**Medway Planning & Economic Development Board  
Meeting**

**Cutler Place**

**Multifamily Development Special Permit,  
Major Site Plan Approval and  
Land Disturbance Permit  
6 Cutler Street**

- Public Hearing Notice dated 11-18-21
- Applications – Site Plan, Multi-Family Special Permit, Land Disturbance Permit
- Site Plan dated 11-17-21 by Ron Tiberi, P.E. with architectural drawings dated 11-17-21 by Alex Siekierski, R.A.
- Waiver Requests
- Plan review comments dated 12-6-21 by Susy Affleck-Childs
- SAC email dated 11-29-21 to Town staff requesting review and comments. None received to date.
- Abutter comment memo dated 12-5-21 from Chris and Kathleen Meo, 16 Cottage Street. This was forwarded to the applicant.
- **DRC Review Letter dated 12-10-21**
- **Abutter comment memo dated 12-14-21 from Julie Harrington, 5 Phillips Street.**
- **Tetra Tech review letter dated 12-14-21.**

PROPOSED DRAINAGE  
& GRADING PLAN  
IN  
MEDWAY, MASSACHUSETTS

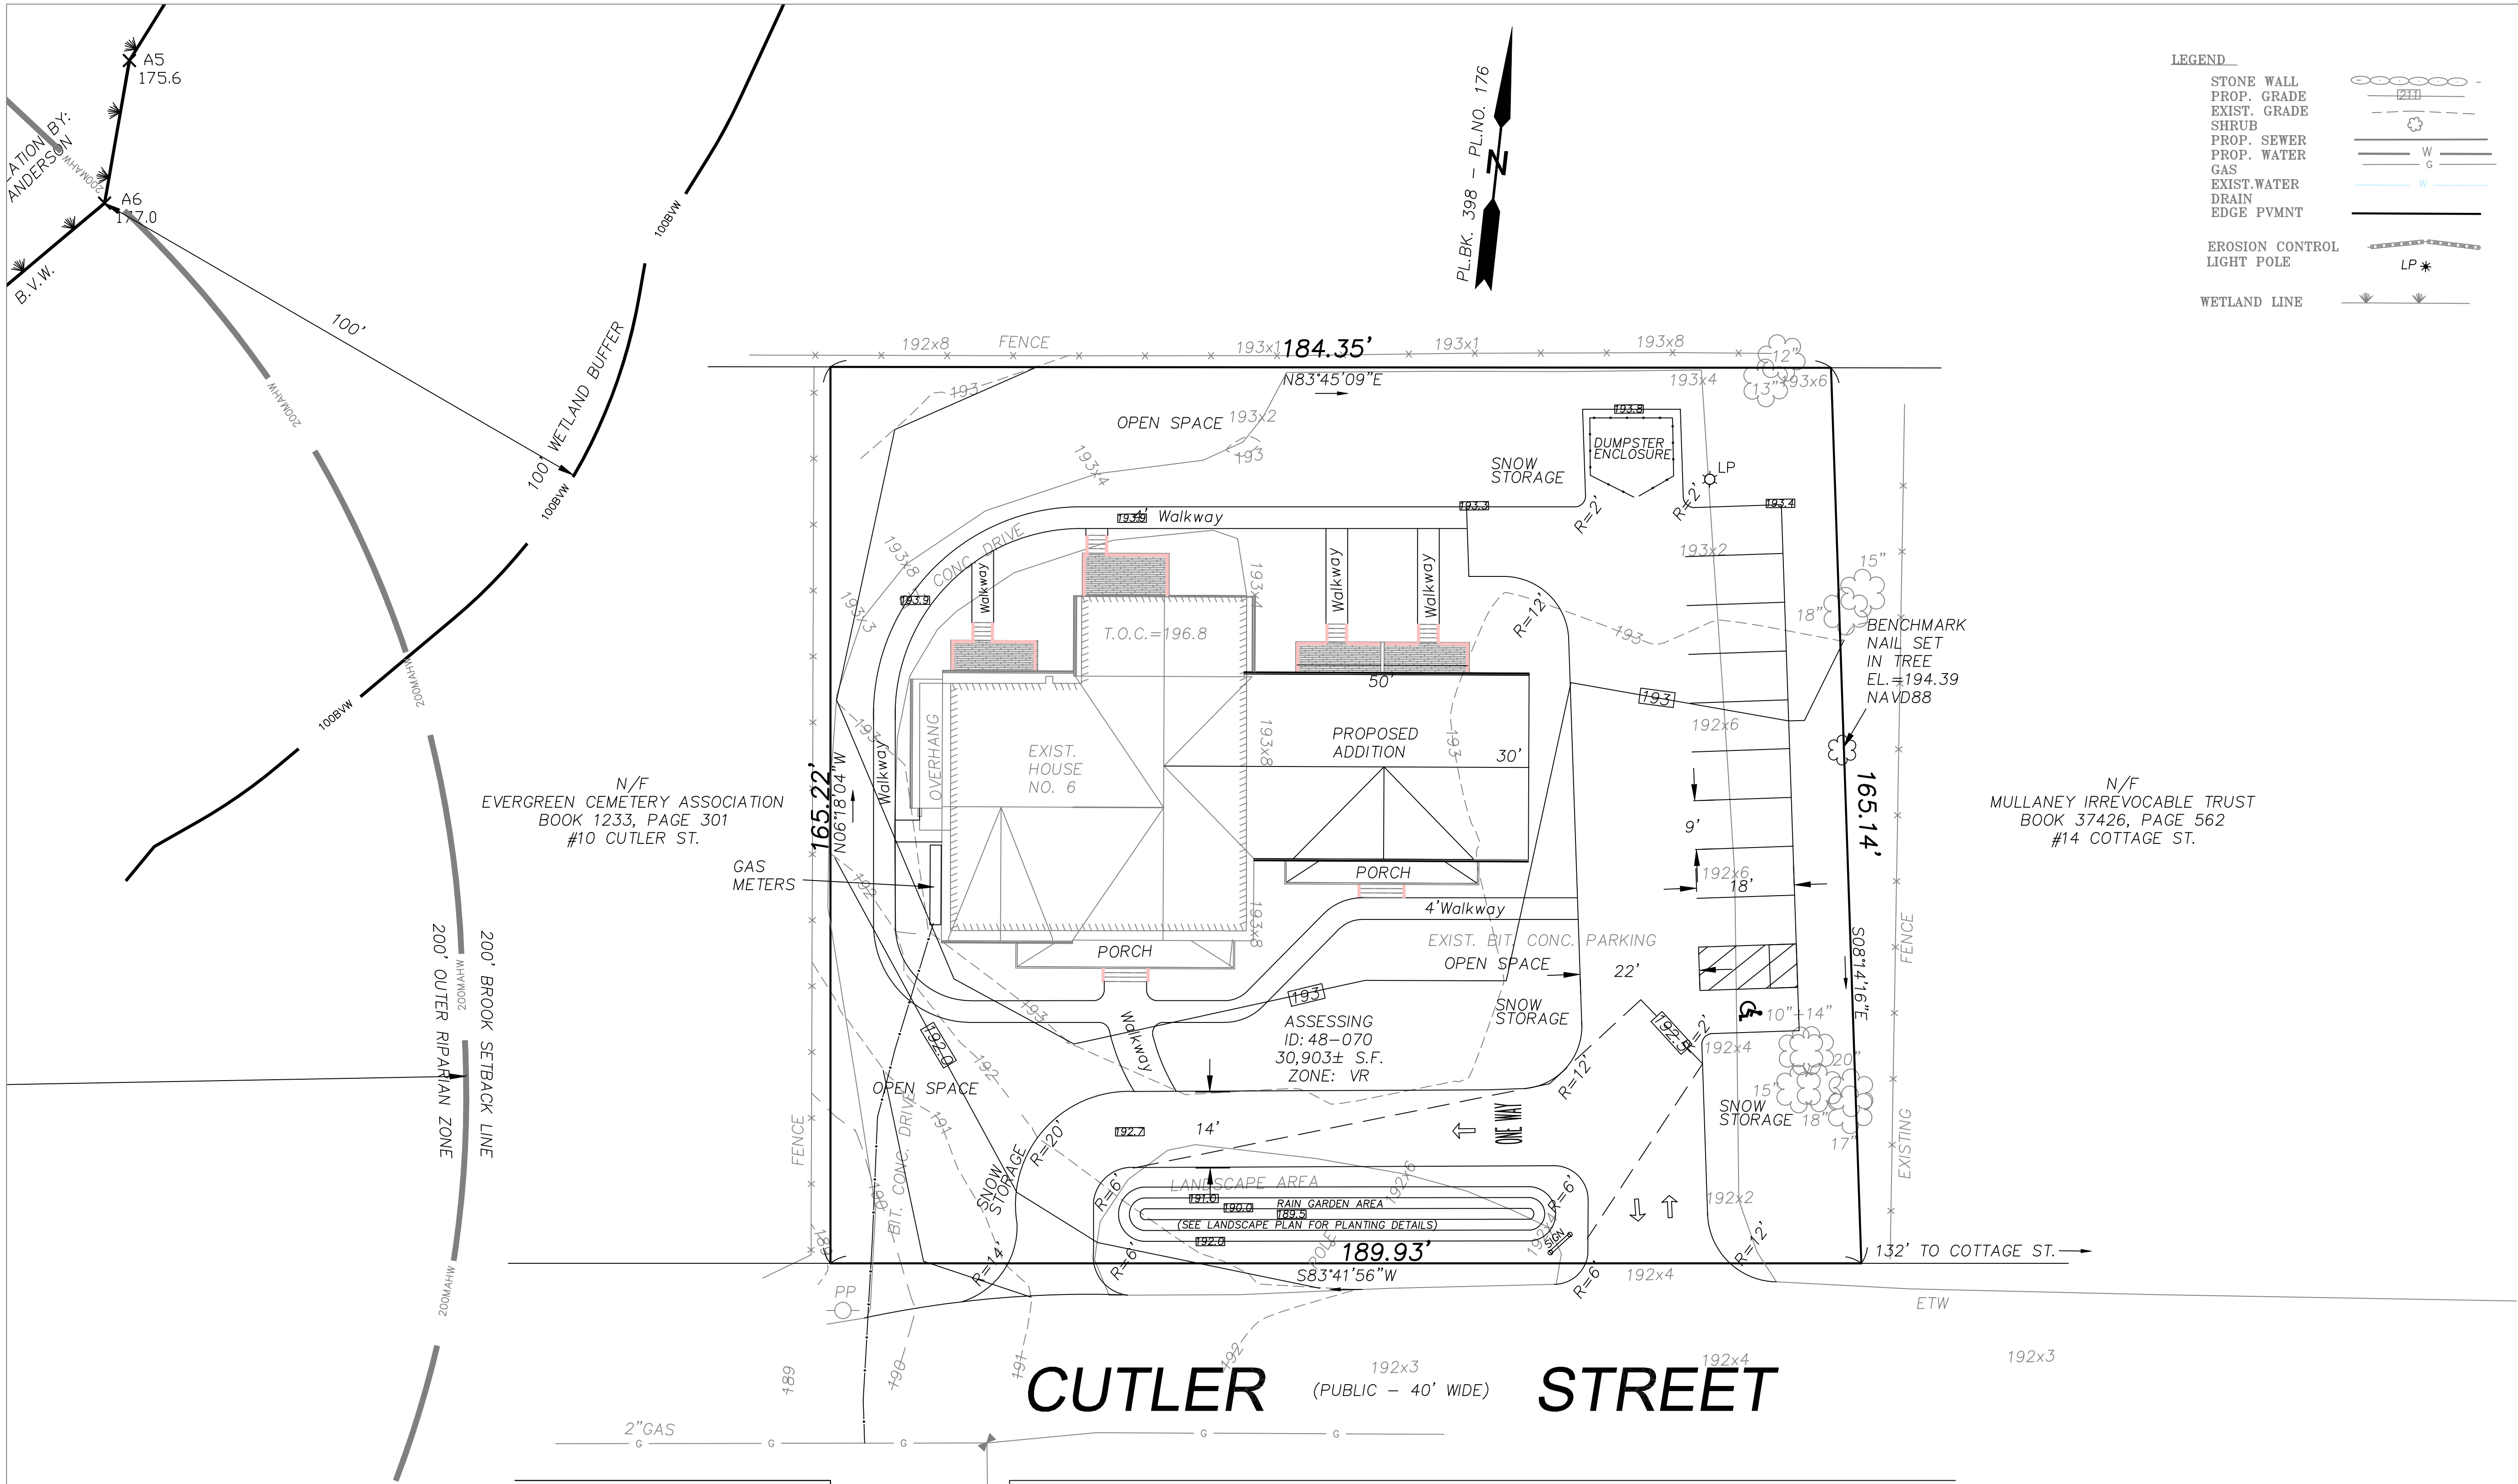
41. We recommend the applicant show on the Proposed Drainage and Grading Plan the 3-foot wide rip-rap weir, rain garden drain, and 8-inch wide stone diaphragm as shown in the construction detail on Sheet S-5 and the HydroCAD analysis. If a drain is proposed for the rain garden, this orifice should be modeled in the HydroCAD analysis and should be shown on the Plans.
